## TECHNICAL NOTE TN-1032-AN

### Implementing Channel Increment and Decrement on the TB7100

All TB7100 User Interface (UI) PCB's with IPN 220-02076-04 or earlier

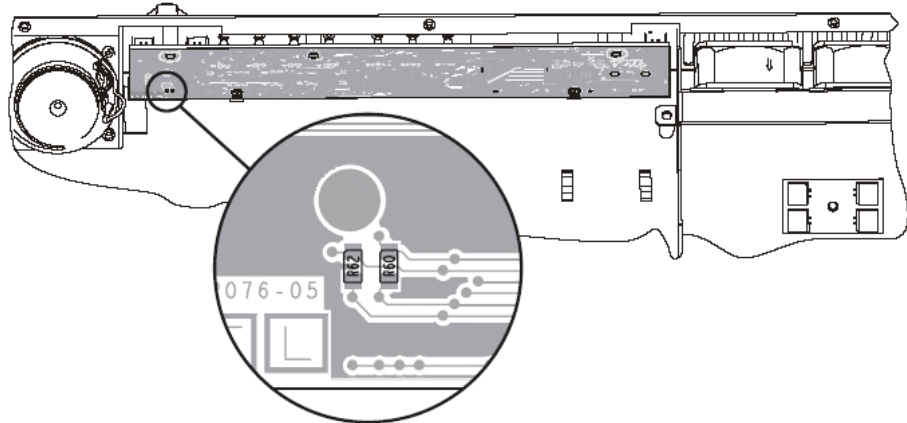
There is however, an issue with the modification details included in the 'Installation and Operation Manual' Page 106, and performing *only* this modification *will not* enable the Increment and Decrement feature. This is due to a hardware design error on the UI board.

Fitting the resistors R60 and R62 as per the manual does connect the Increment and Decrement function lines as required however this modification does not disconnect the programmed F1 and F2 key functionality. Consequently the TB7100 attempts to action both operations simultaneously. (i.e Function 1 + Channel Decrement, Function 2 + Channel Increment).

Therefore, further modification is required to electrically disconnect the standard F1 and F2 control lines from the F1 and F2 UI buttons.

There are three steps to the modification required to implement the Channel Increment and Decrement feature.

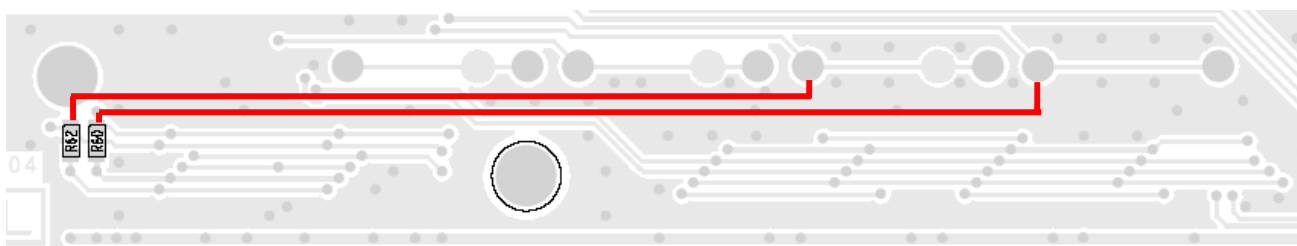
Fit 2 x zero ohm resistors in positions R60 and R62 as shown below. The zero ohm resistors can be substituted with solder shorts if this is found to be easier, however as tracks run between these pads a resistor is recommended.

Two tracks require cutting in two locations. This can be achieved using a sharp blade or similar cutting instrument. The locations to make the track cuts are shown below.

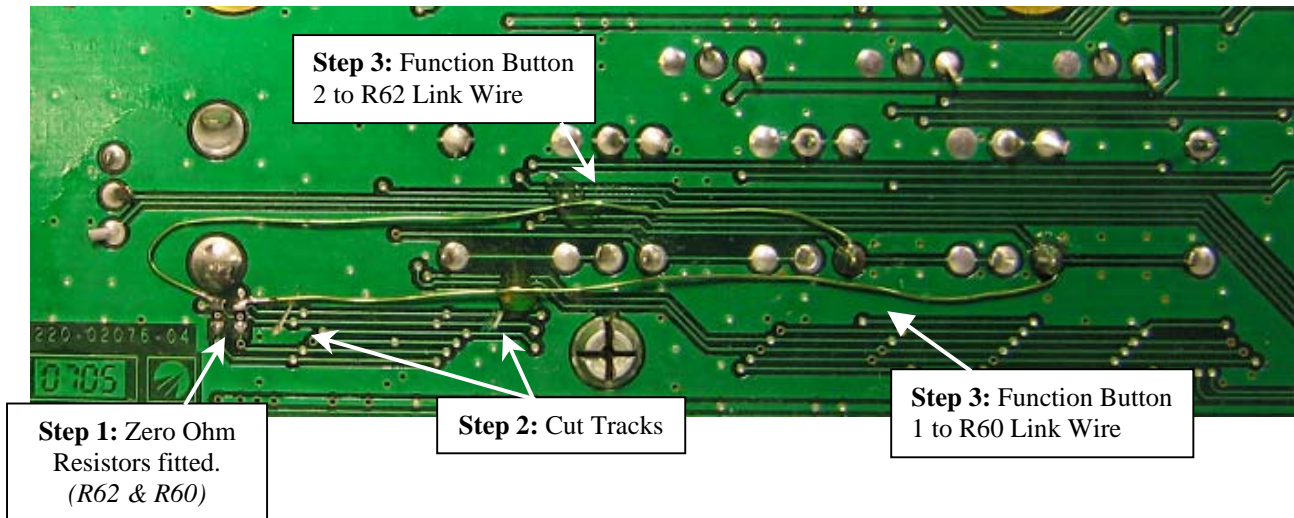
Linking wires need to be fitted to the UI to connect R62 to Function Button 2, and R60 to Function Button 1. This is achieved by soldering one end of the wire to either end of the named resistor, and soldering the other end of the wire to the appropriate leaded button leg on the rear of the UI board. The configuration/layout is shown below.

A photograph of a modified unit is included below that illustrates all the required modifications.
